Zoning Staff Report

Case Number: ZC-23-022

Zoning Map Amendment & Site Plan

Site Location: 5819 Bowman Roberts Road

**PRELIMINARY SITE PLAN
FOR
BOWMAN ROBERTS SINGLE FAMILY**

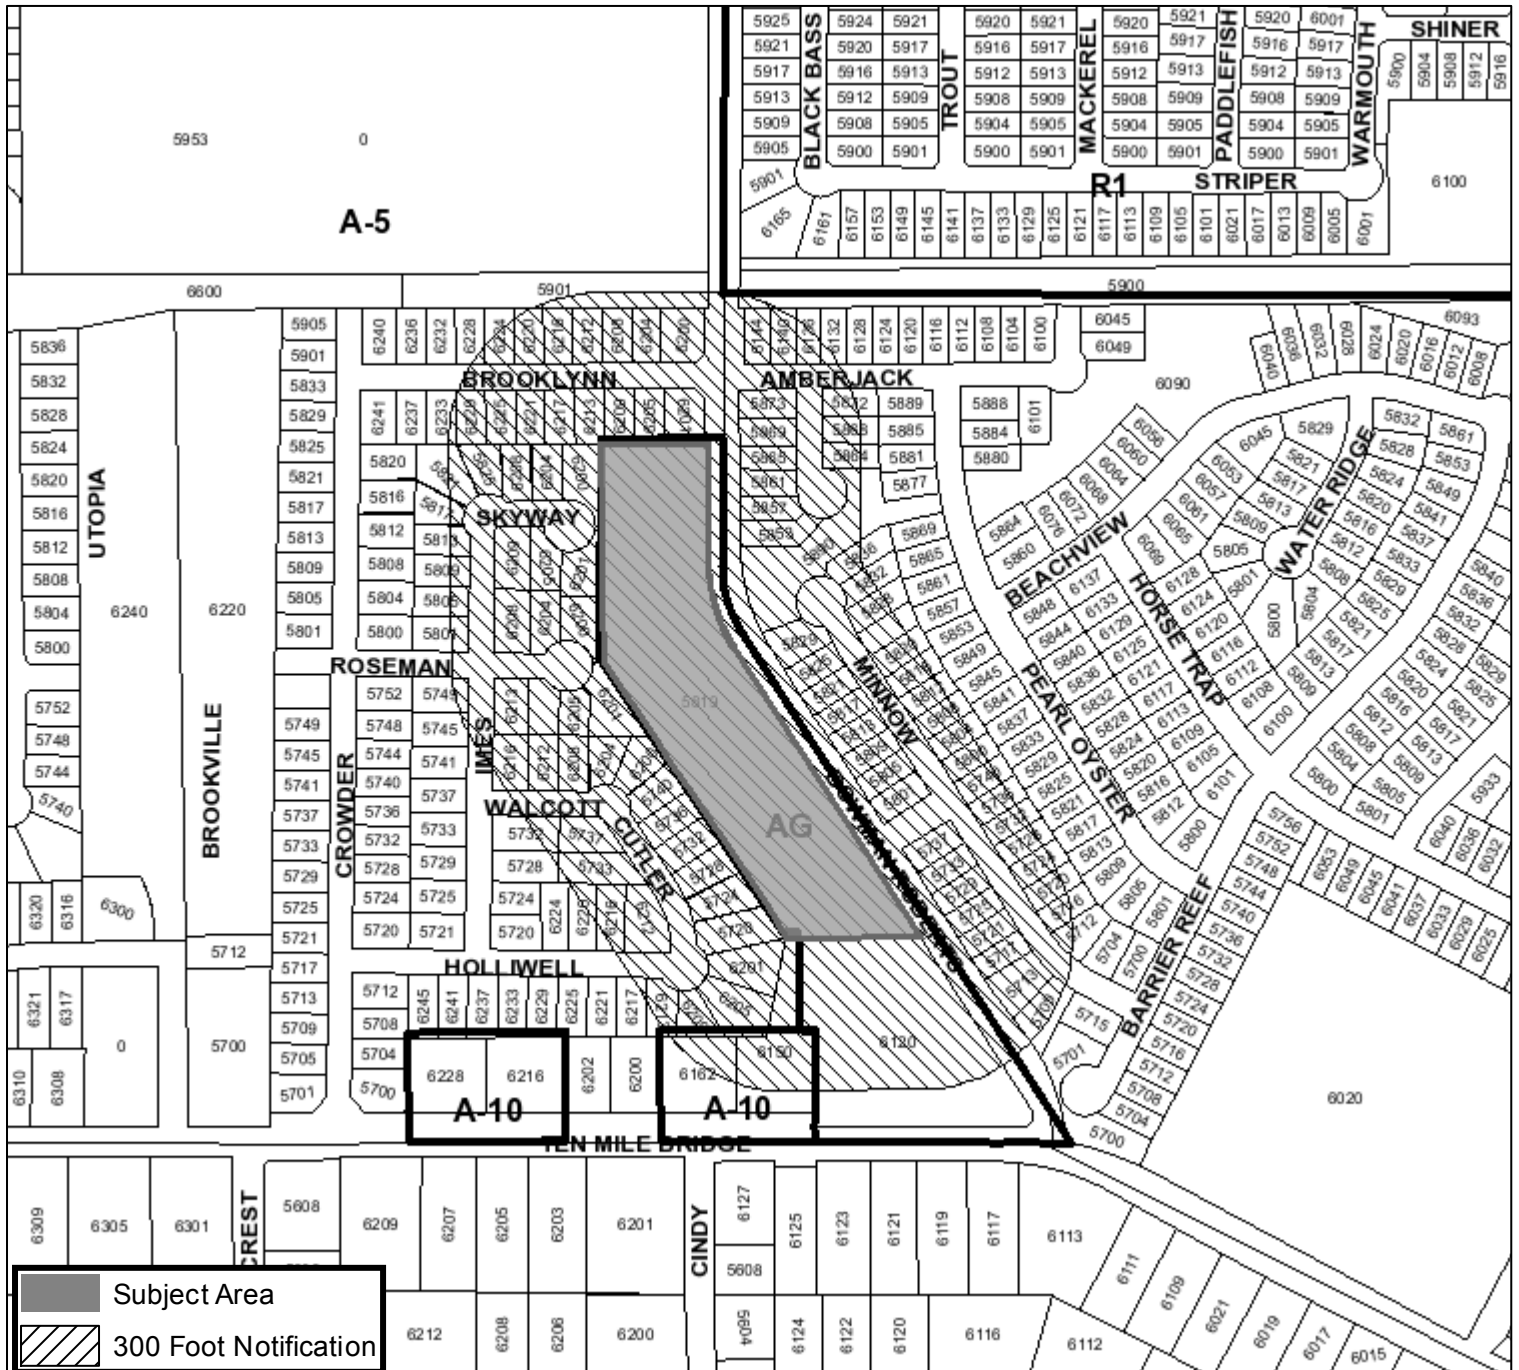
- Add case reference ZC-23-022.
- Include height information on Site Plan (max height is 36 feet measured from slab to top plate).
- Is 10' the height for all buildings (including amenity/office)?

- Correct general note 4 for landscaping referencing Section 4.712.d.6.a instead of "A1 Districts".
- Correct general note 10, specify ..."D" District Standards from Section 4.712 of the Ordinance, with following exceptions.

- Replace Community Design Standards with Waiver Exhibit table.
- Remove Cottage Community Design Standards (can be on building plans, not on Site Plan).

- Remove references to signage in Waiver Exhibit table, strike "Monument sign may be within this setback".
- Confirm with [Stormwater](#) section that they are okay with 4 fences across central drainage easement.

- Public sidewalk on private property will potentially need an encroachment agreement / easement, contact [Contracts](#) section.
- Current waiver list would include Parking, Supplemental Building Setbacks, Open Space, Building Orientation, Perimeter Fencing, MFD Submittal waiver

This project is considered multi-family for fire code based on parking configuration.

26' wide Fire lanes are compliant.

Hammerhead turn-around dimensions must be 50' long for each short section of the "T".

One point of access is compliant. (fewer than 100 units)

All unit addresses must be visible from the fire lane. Fencing may block visibility of some units on west side. Each building address shall be clearly visible from the corresponding street.

Hose lay to each building must be provided within 150' from the edge of a marked fire lane or public street, measured in a 5' wide unobstructed path.

Additional hydrants are required to meet the following: Section 507.5.1(2)

Maximum of 600 ft. (300 ft. radius) of space between hydrants along a direct horizontal line, and

Maximum of 500 ft. hose lay distance to all points of building.

Land disturbance is greater than 1 acre, a drainage study will be required before obtaining a grading permit or submitting to IPRC. Grading permit will be required prior to obtaining any building permits. The fence across the drainage easement will need to be reviewed with an encroachment agreement. There will need to be plan profiles showing the vertical distance between the fence poles/concrete footing and the top of the 42" storm pipe. There may also be some minor overland flows, your drainage study should be able to identify those, if overland flows exist, the fence would need to be rod iron.

1. Gated Entrances: Gated entrances into secured areas must be designed in accordance with TPW's "Traffic Engineering Design Standards and Policy Guidelines". Gates must permit stacking of three of the largest vehicles off right-of-way and include a turnaround for denial of access on private property. Gates shall be equipped with a Knox-box or other approved fire access apparatus that is to be reviewed and approved by the Fire Department.

o Residential/Multi-Family-3 stacking spaces from the call box required entrance

All zoning comments have been addressed:
